CITY OF ALBUQUERQUE

Re: Pima Medical Institute/ New Classroom Building
4400 Cutler Ave. NE
30-Day Temporary Certificate of Occupancy
Transportation Development Final Inspection
Architect's Stamp dated 04-26-22 (H17-D054B)
Certification dated 10-12-22

As-Built Traffic Circulation Layout
10/12/2022

New ADA curb ramp and crosswalk stripping

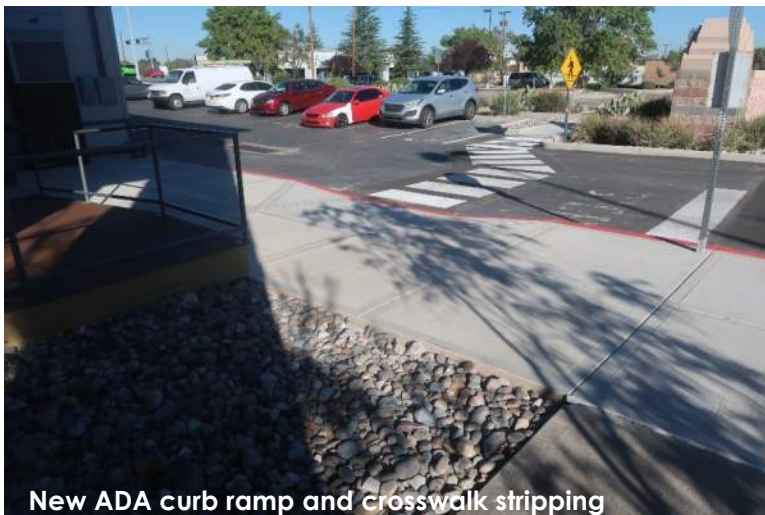
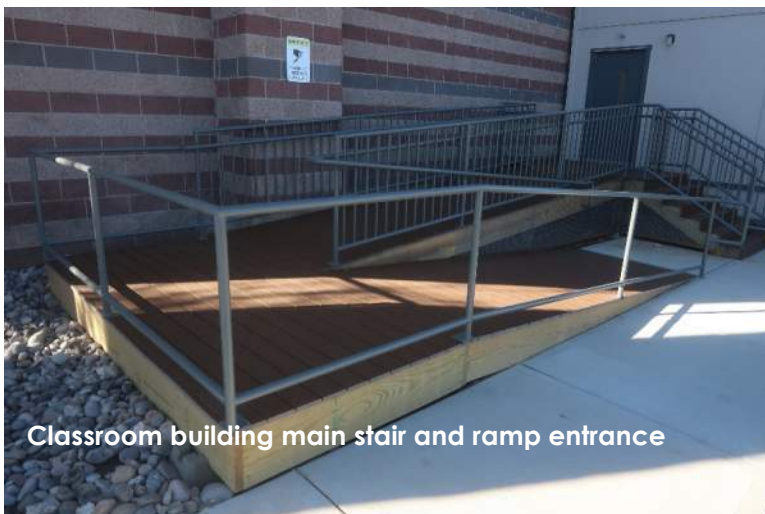
- Handicap ramp (keyed note 5, TCL003) was shifted east to accommodate the new ADA-accessible classroom building ramp landing.
- Designated crosswalk striping (keyed note 21, TCL003) was moved east to accommodate the new handicap ramp.

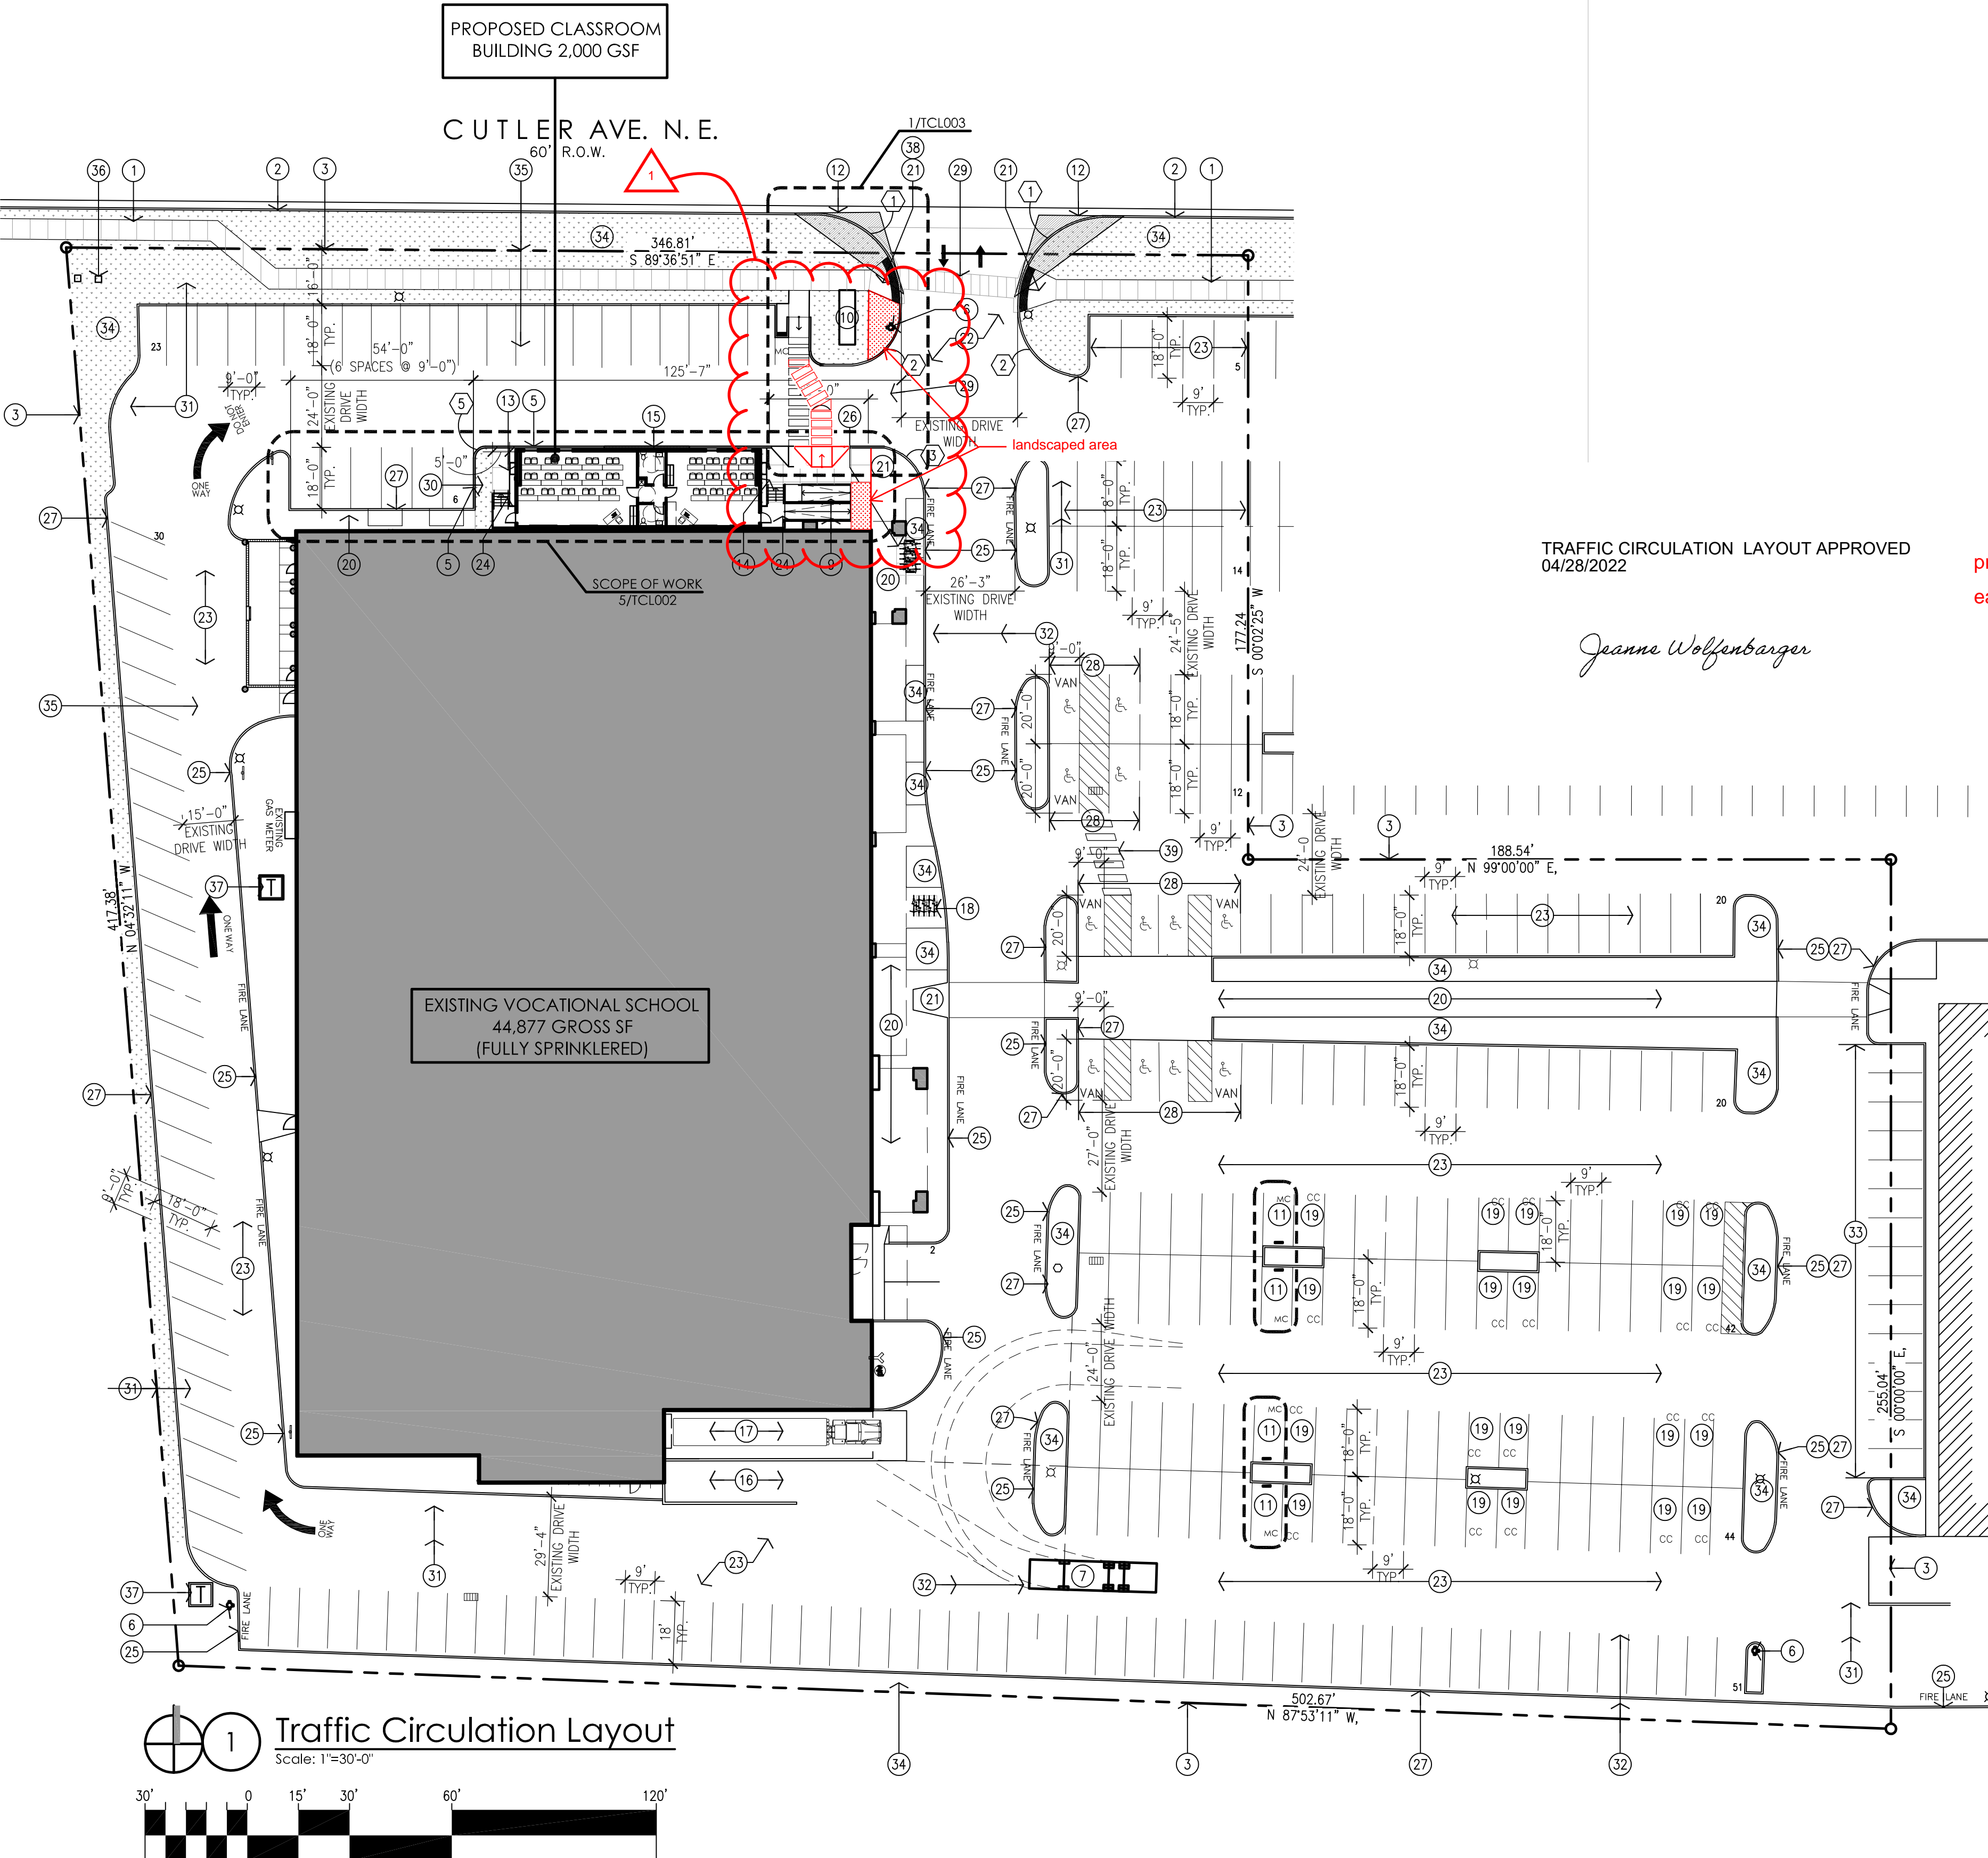
- Keynote 9: per site visit the running slope for the ADA ramp was 9.5%. Per ADA requirements the running slope should not exceed 8.3% (7% preferred slope).
- Keynote 11: Please provide Motorcycle parking spaces per approved plan.
- Keynote 39: Per approved TCL, please provide 6 ft. wide crosswalk.
- Prior to final Certification of Occupancy, please provide City sidewalk easement.
